**Advanced Passive 1000 (AP1000)
Generic Technical Specification Traveler (GTST)**

Title: Changes Related to LCO 3.7.6, Main Control Room Emergency Habitability System (VES)

Figure B 3.7.6-12 (page 1 of 1)
Compressed Air Storage Tanks Minimum Volume – One Bank of VES Air Tanks (8 Tanks)
Inoperable

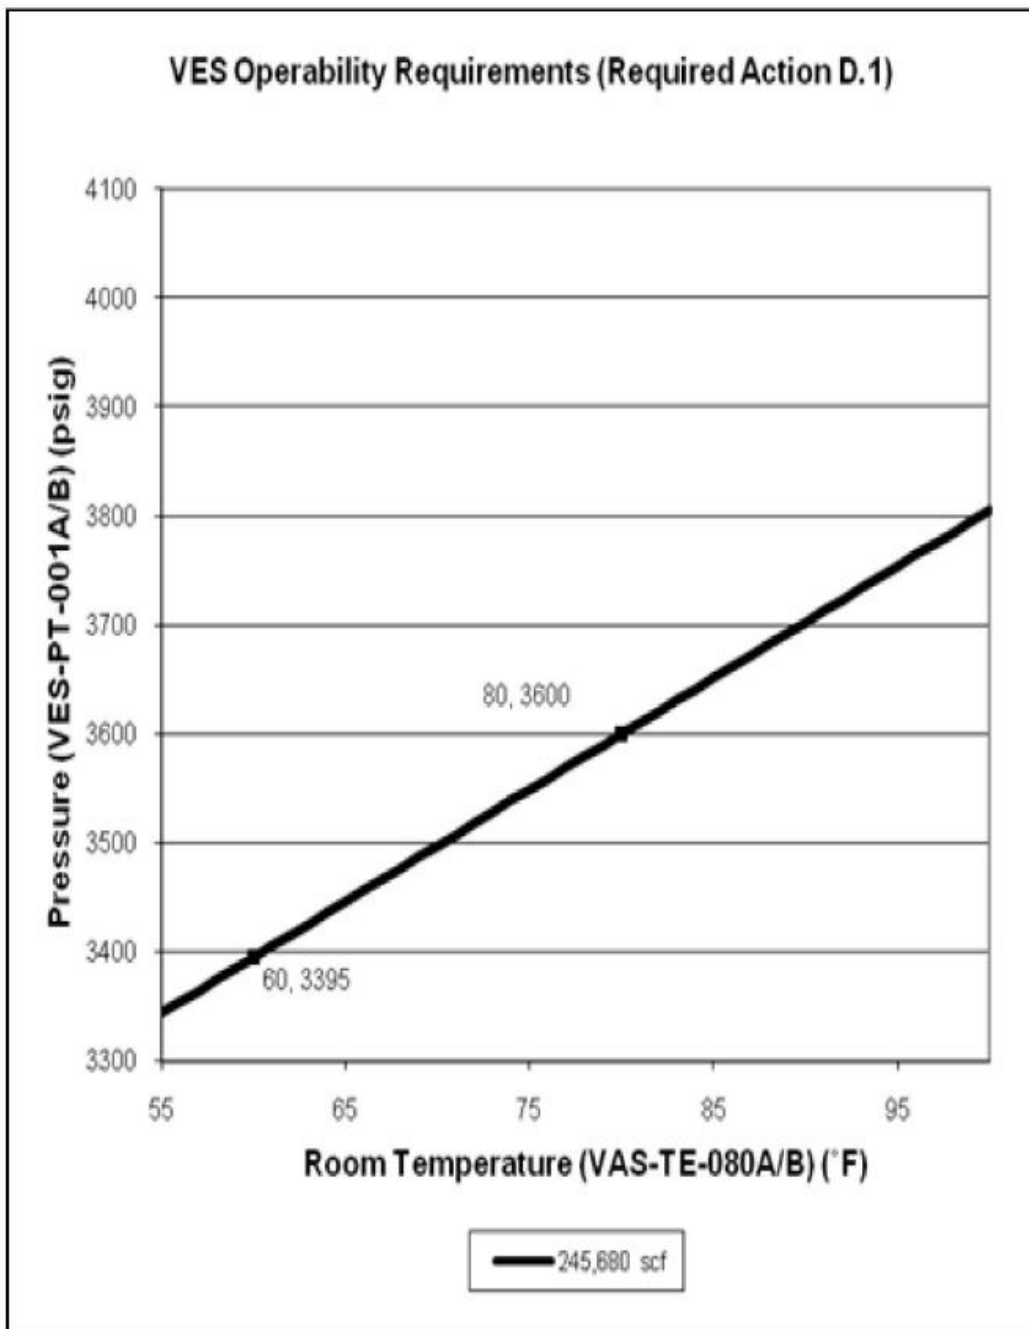
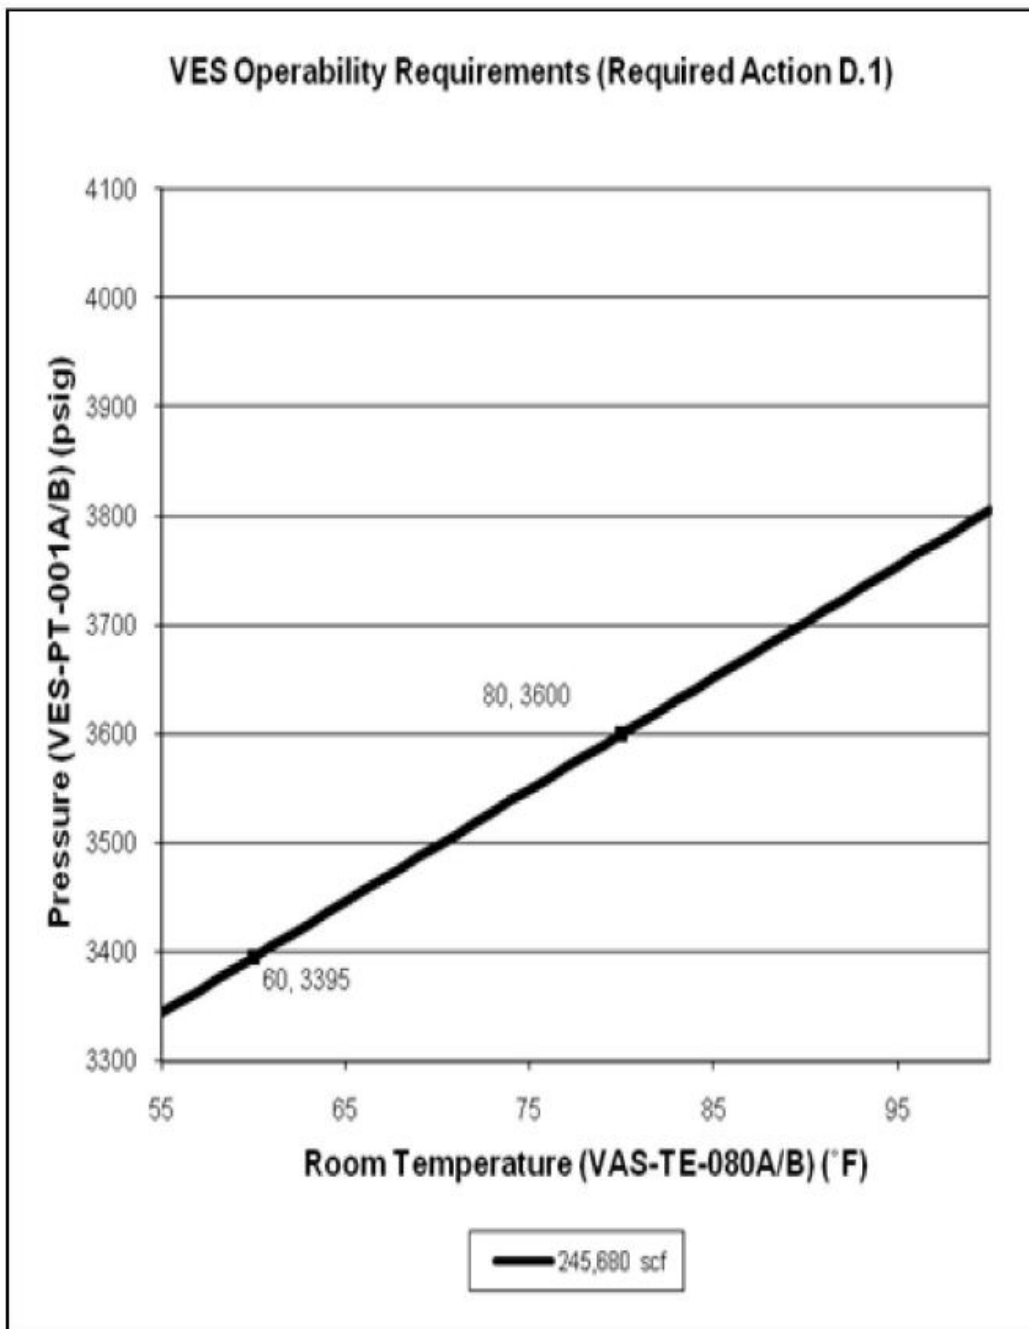
. . . The standard volume is determined using the compressed air storage tank room temperature (VAS-TE-080A/B), compressed air storage tanks pressure (VES-PT-001A/B), and Figure B 3.7.6-~~12~~, Compressed Air Storage Tanks Minimum Volume - One Bank of VES Air Tanks (8 Tanks) Inoperable. . . .

In addition, renumber Figure B 3.7.6-2 as Figure B 3.7.6-1, and Figure B 3.7.6-2 as Figure B 3.7.6-1.

13. (Internal # 422 and 423) Revise TS Bases Figures B 3.7.6-1 and B 3.7.6-2 to add “Acceptable” region labels. The order of the Figures is swapped to align with Writer’s Guide convention. This is resolved by making the recommended change.
14. (Internal #1) Include TSTF-522 in the reference disposition tables, as “TSTF already included in GTS Rev. 19 with variation.” Note that minor changes to the Bases are as appropriate to the AP1000 design.

Figure B 3.7.6-2 is updated and renumbered as Figure B 3.7.6-1, and Figure B 3.7.6-2 is updated and renumbered as Figure B 3.7.6-1. (APOG Comment)

Figure B 3.7.6-1 (page 1 of 1)
Compressed Air Storage Tanks Minimum Volume – One Bank of VES Air Tanks (8 Tanks)
Inoperable

Figure B 3.7.6-24 (page 1 of 1)
Compressed Air Storage Tanks Minimum Volume

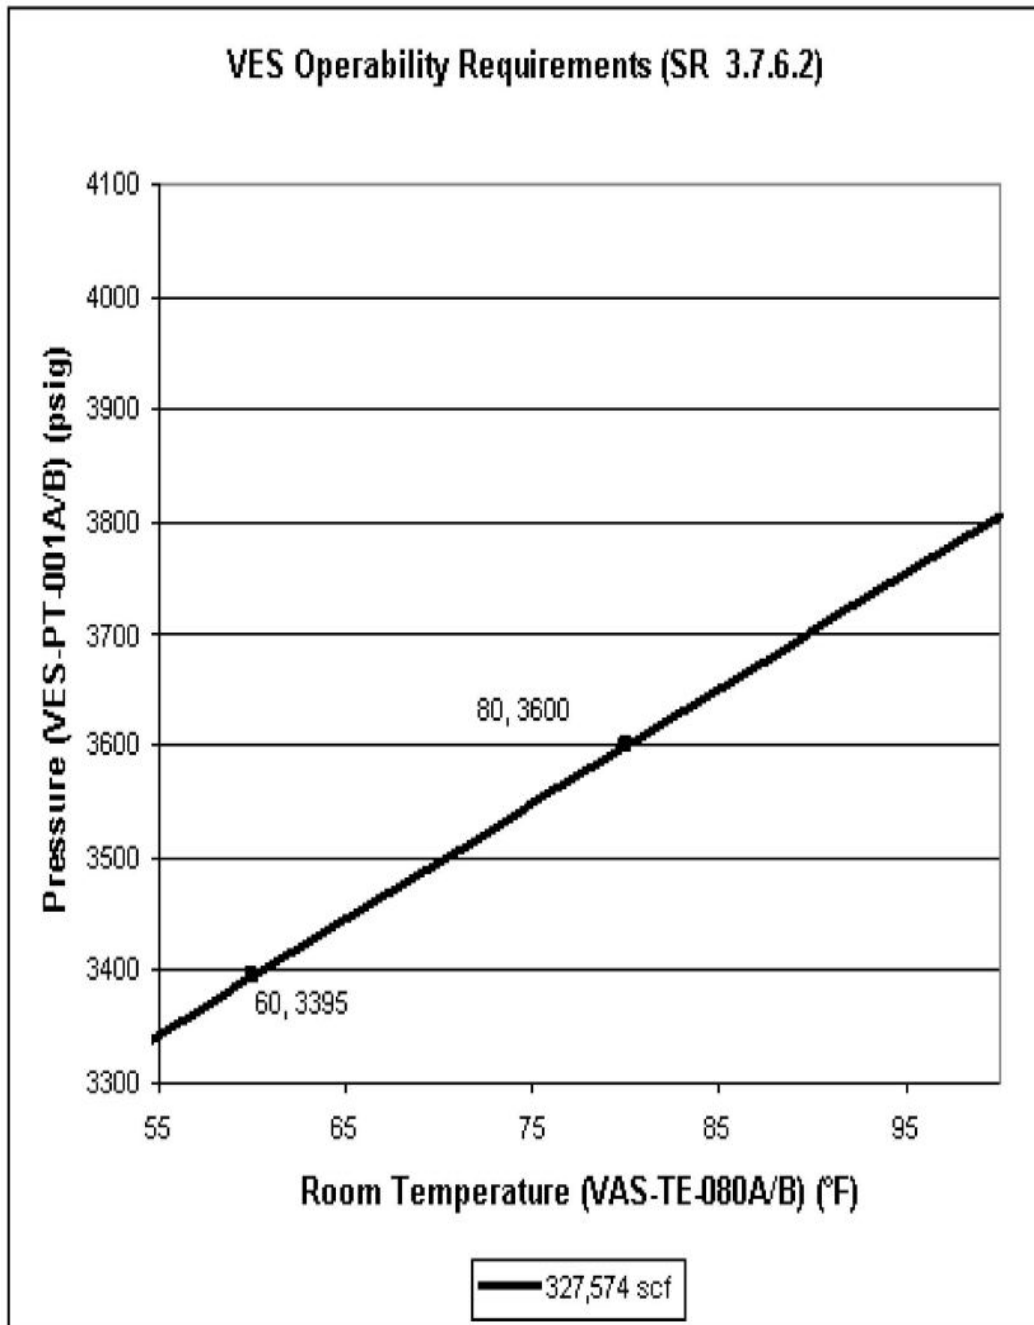
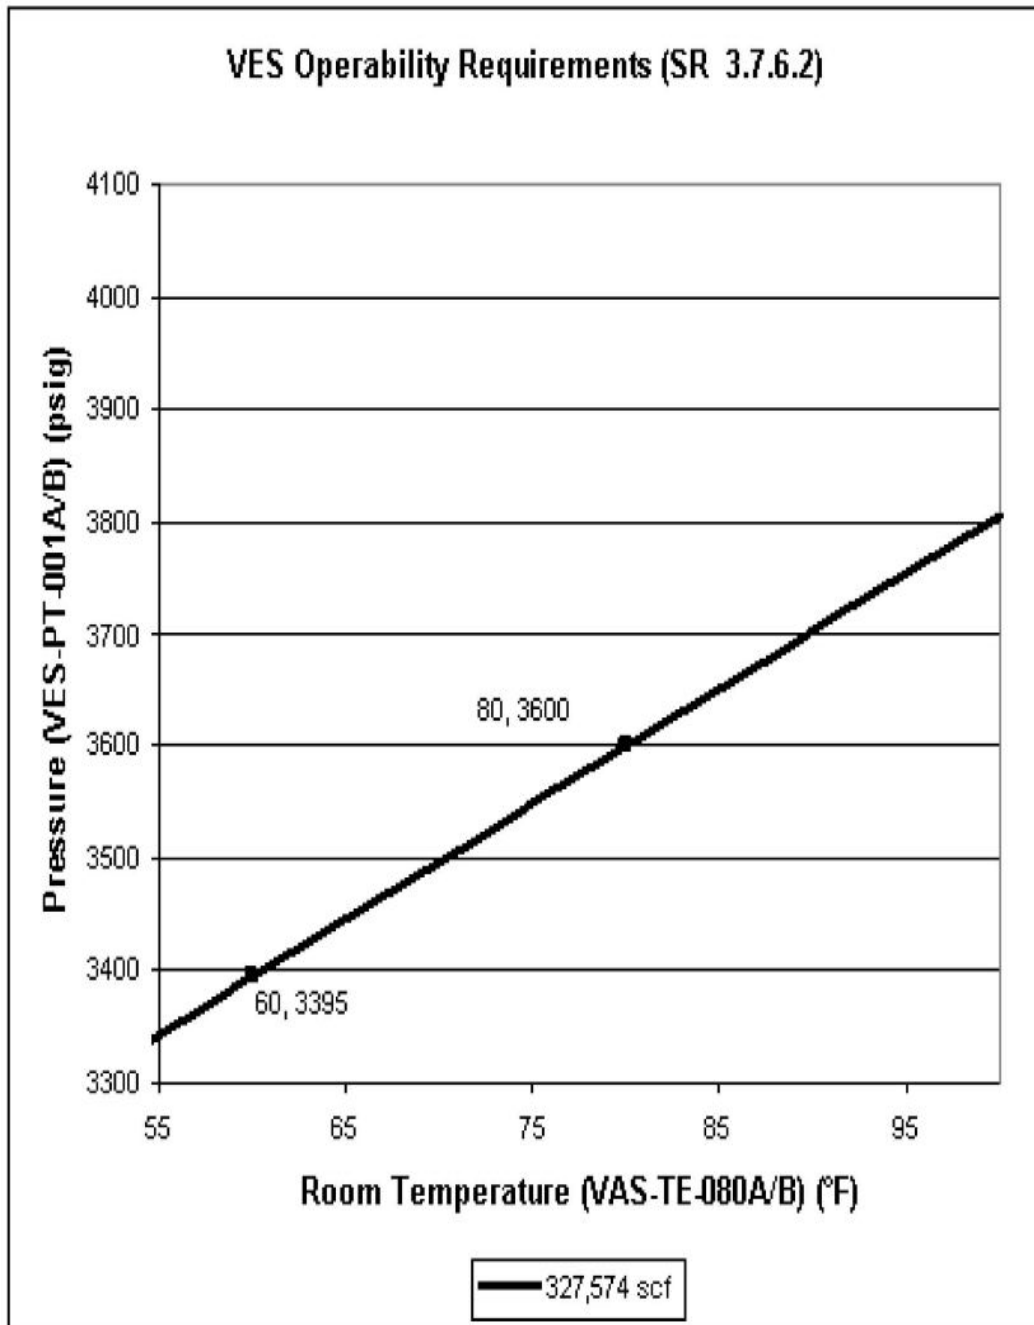
The standard volume is determined using the compressed air storage tank room temperature (VAS-TE-080A/B), compressed air storage tanks pressure (VES PT 001A/B), and Figure B 3.7.6-~~24~~, Compressed Air Storage Tanks Minimum Volume. . . .

Figure B 3.7.6-2 (page 1 of 1)
Compressed Air Storage Tanks Minimum Volume
